BROADWAY-DAWES SUBDIVISION

APPLICATION NUMBER 4 DATE April 5, 2018

REQUEST Subdivision

DETAIL SITE PLAN

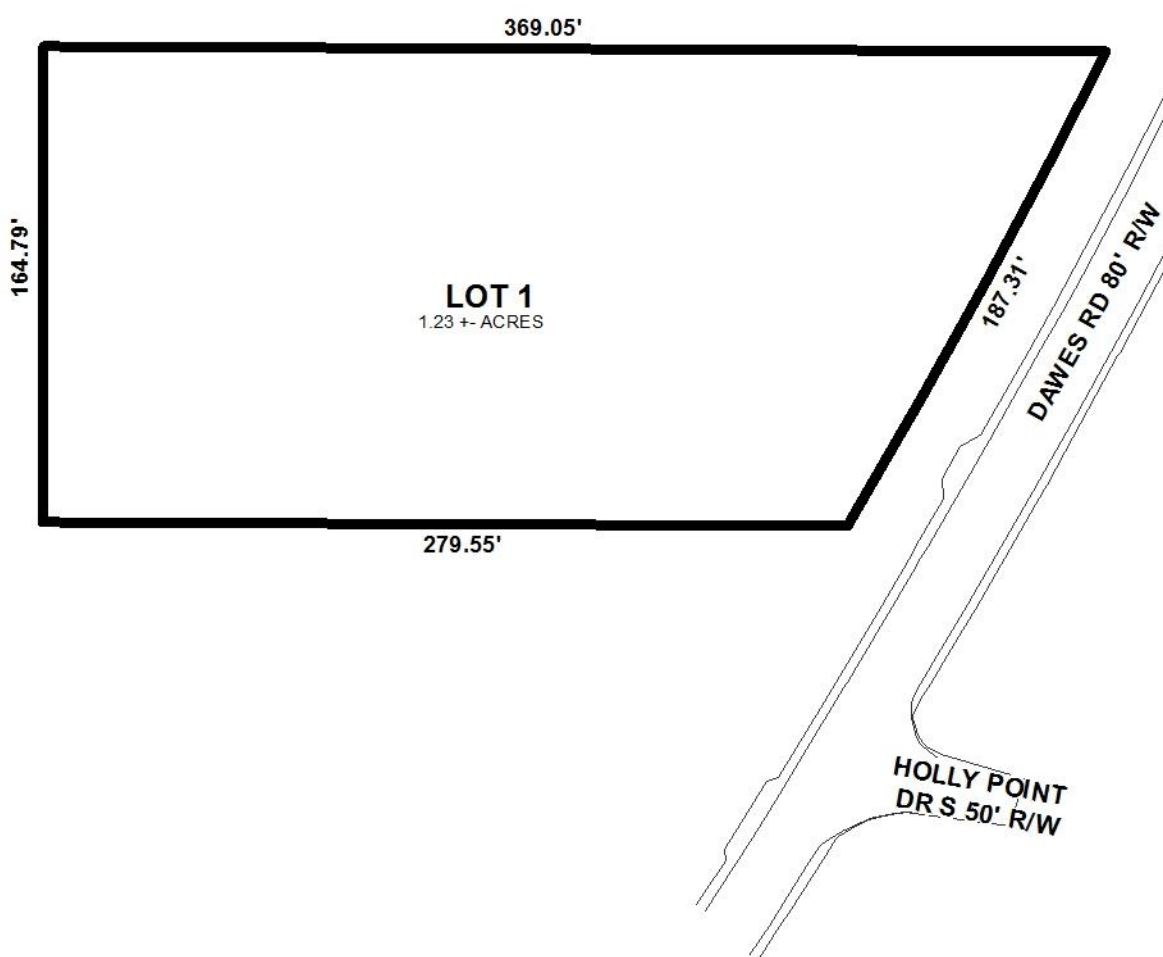
The proposed lot has frontage on Dawes Road, a proposed major street with a required 100' right-of-way per the recently adopted Major Street Plan. The plat illustrates an 80' right-of-way at this location; therefore, if approved, the plat should be revised to illustrate dedication sufficient to provide at least 50' from the centerline of Dawes Road.

The lot meets the minimum size requirements for lots served by a public water supply and a sanitary sewage system, and is appropriately labeled in square feet and acres on the preliminary plat. This information should be retained on the Final Plat, if approved, adjusted for any required dedication; or, provision of a table providing the same information on the Final Plat may suffice.

The 25' minimum building setback line required by Section V.D.9. of the Subdivision Regulation is not illustrated on the preliminary plat. As such, revision of the plat to illustrate the 25' minimum building setback line along Dawes Road should be required, if approved, adjusted for any required dedication.

With regards to access management, a note on the preliminary plat limits the lot to one (1) curb cut to Dawes Road, with any changes in its size, location or design to be approved by Mobile County Engineering and conform to AASHTO standards. This note should be retained on the Final Plat, if approved.

The site is located in the County, thus any lots which are developed commercially and adjoin residentially developed property must provide a buffer in compliance with Section V.A.8. of the Subdivision Regulation. A note regarding this requirement has been placed on the preliminary plat and should be retained on the Final Plat, if approved.

Finally, the site will have to comply with the City of Mobile storm water and flood control ordinances. A note stating *“Must comply with the Mobile County Flood Damage Prevention Ordinance. Development shall be designed to comply with the storm water detention and drainage facility requirements of the City of Mobile storm water and flood control ordinances, and requiring submission of certification from a licensed engineer certifying that the design complies with the storm water detention and drainage facility requirements of the City of Mobile storm water and flood control ordinances prior to the issuance of any permits.”* has been placed on the preliminary plat and should be retained on the Final Plat, if approved.

- 1) revision of the plat to dedicate at least 50' from the centerline of Dawes Road;
- 2) retention of the lot's size in square feet and acres on the Final Plat, or the provision of a table on the Final Plat providing the same information, adjusted for dedication;

- 3) revision of the plat to illustrate the 25' minimum building setback line along Dawes Road, adjusted for dedication;
- 4) retention of a note on the Final Plat stating the lot is limited to one (1) curb cut to Dawes Road, with any changes in its size, location, or design to be approved by Mobile County Engineering and conform to AASHTO standards;

- 5) retention of a note on the Final Plat stating lots which are developed commercially and adjoin residentially developed property must provide a buffer, in compliance with Section V.A.8. of the Subdivision Regulations;

- 6) retention of a note on the Final Plat to comply with the Mobile County storm water and flood control ordinances: *“Must comply with the Mobile County Flood Damage Prevention Ordinance. Development shall be designed to comply with the storm water detention and drainage facility requirements of the City of Mobile storm water and flood control ordinances, and requiring submission of certification from a licensed engineer certifying that the design complies with the storm water detention and drainage facility requirements of the City of Mobile storm water and flood control ordinances prior to the issuance of any permits.”*; and,

- 7) compliance with Fire Department comments: *“Projects outside the City Limits of Mobile, yet within the Planning Commission Jurisdiction fall under the State or County Fire Code (2012 IFC.)”*
